ABBATTITORI/CONGELATORI  
BLAST CHILLERS AND FREEZERS

## BLAST CHILLER/FREEZER 20 GN 1/1 CROSSWISE 100/85 Kg

**Marchio / Brand: Zanussi /Alpeninox**  
**Paese / Country: Tutti / All**

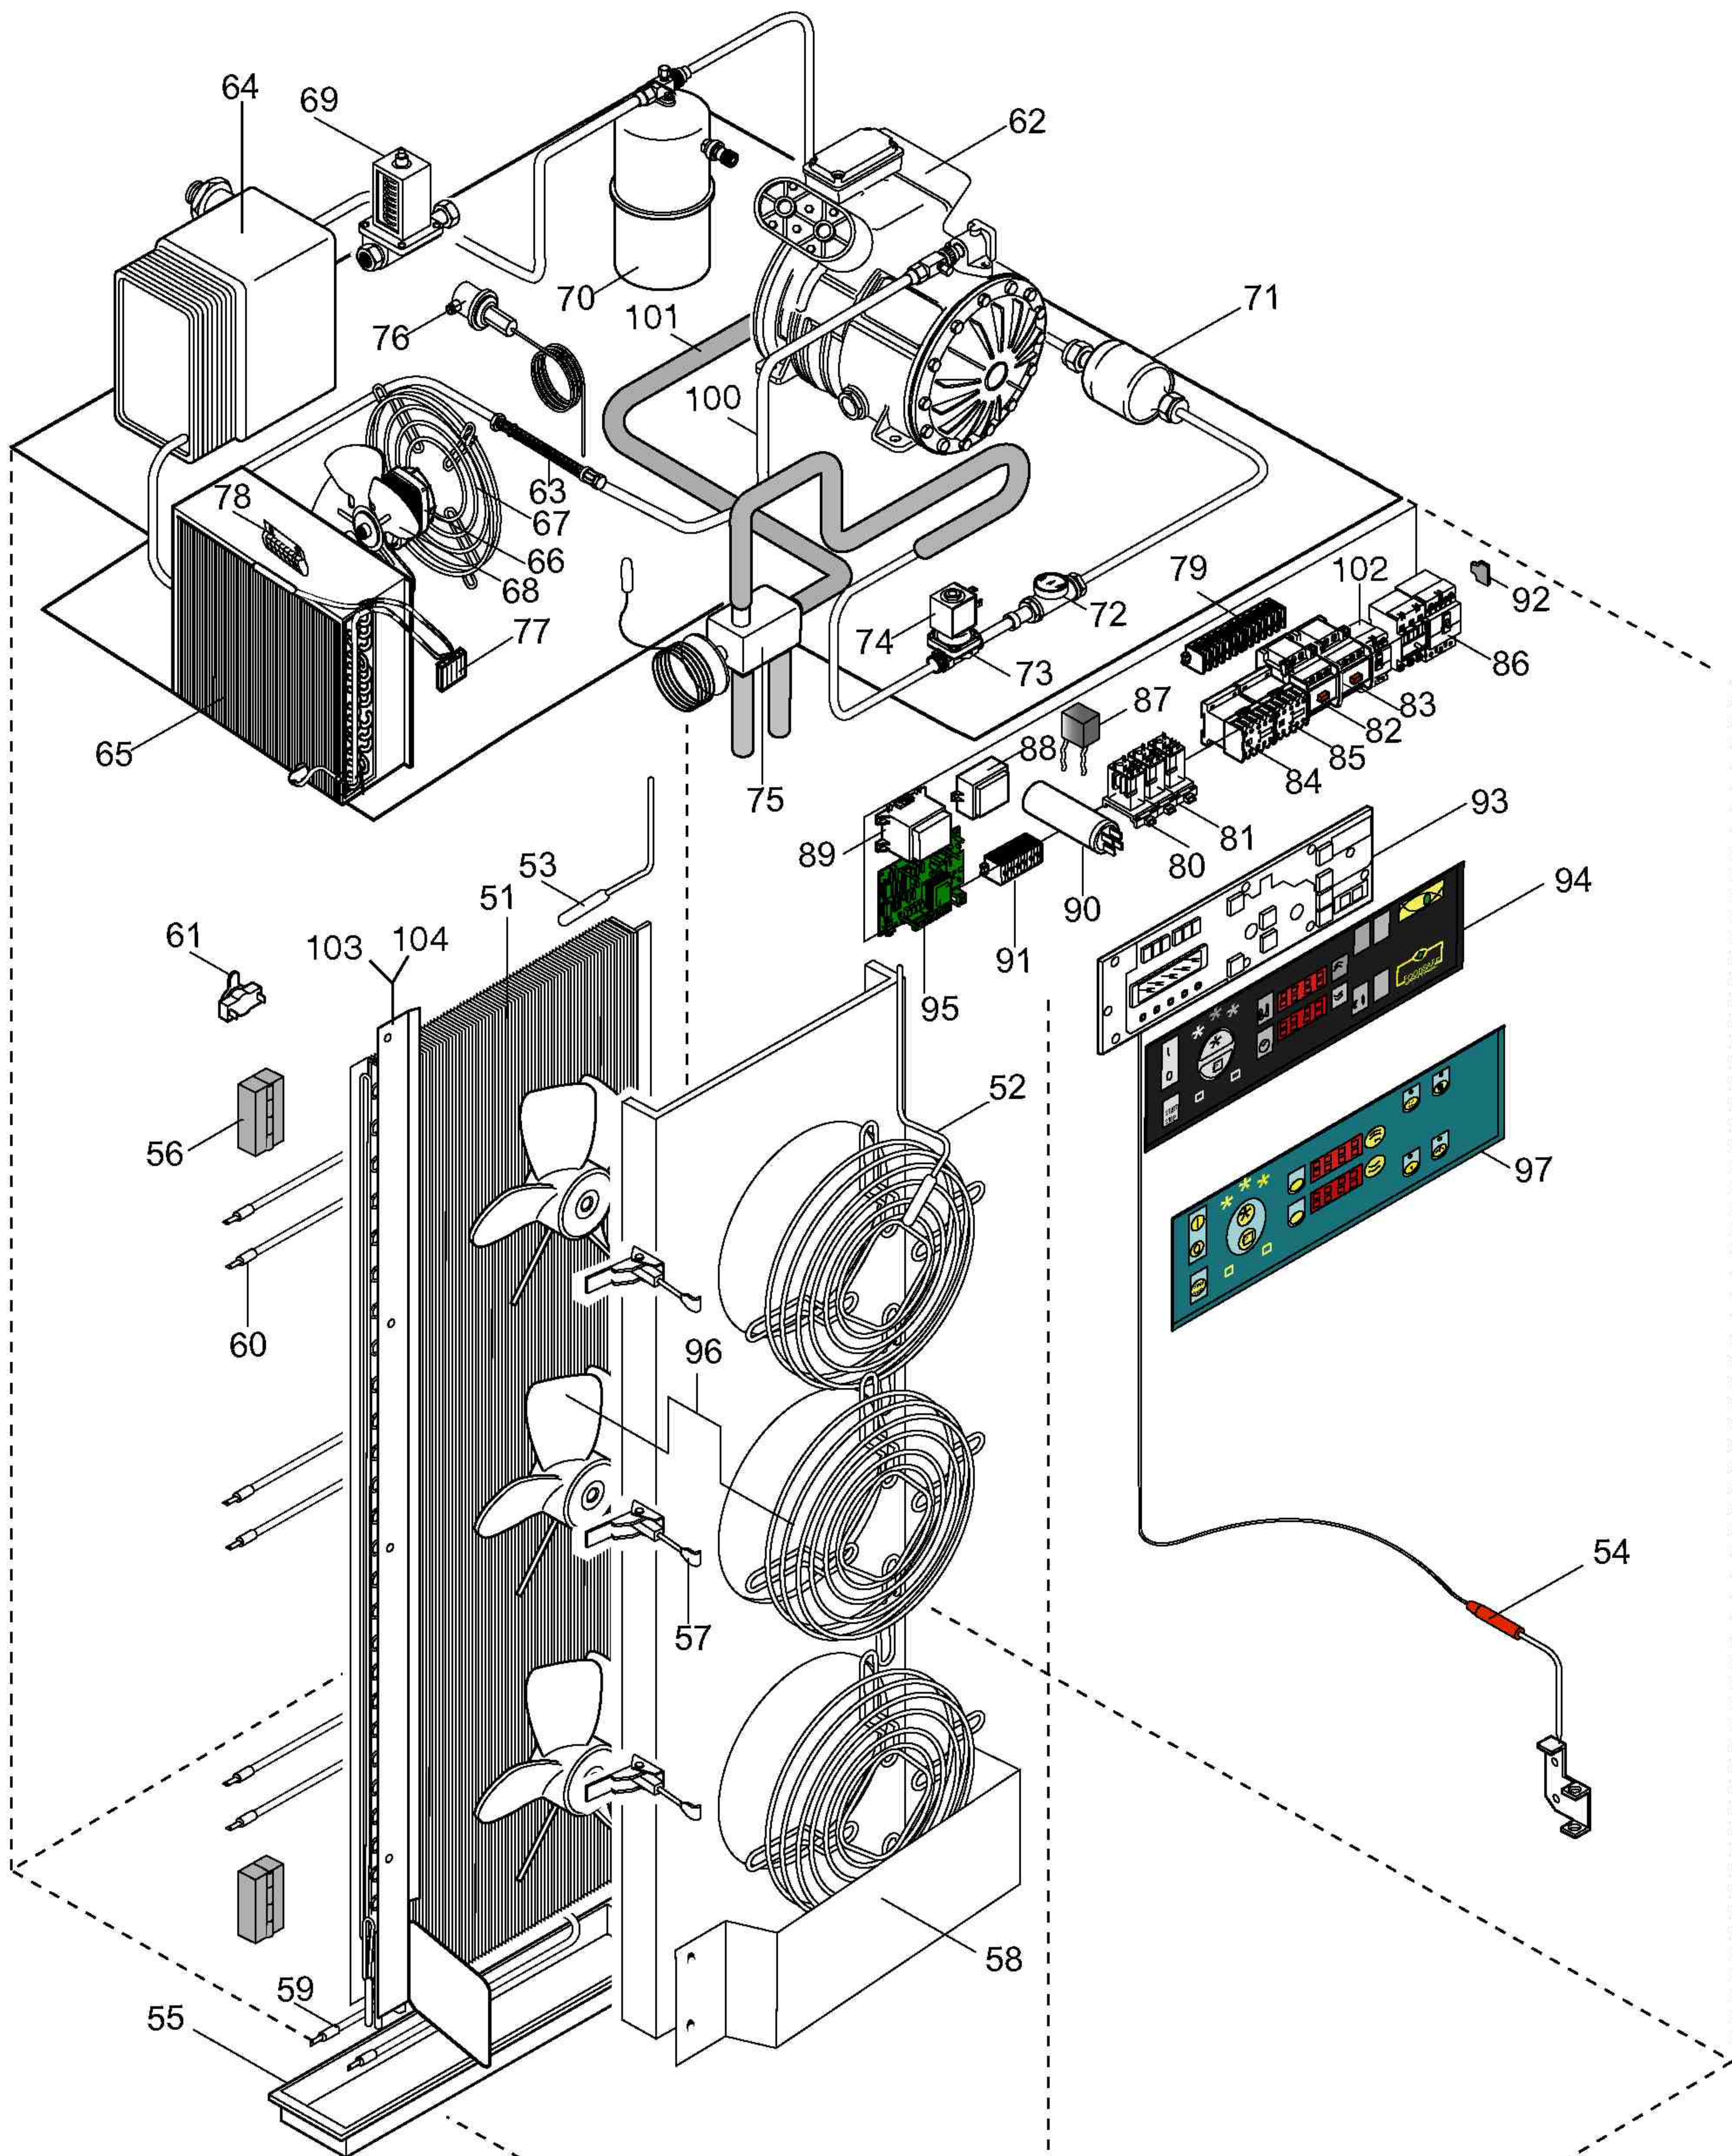
**Has been change the user board and food probes from ser.N°01700001 due to a new connectors. Please for other information look the tec.doc n°VTX.2010-03**

from serial number **642**..... in Pnc n° 110001-110022-728312-728334 change compressor from spc 084938 to 091214 from serial number **7120001** change electronic board, stiker control
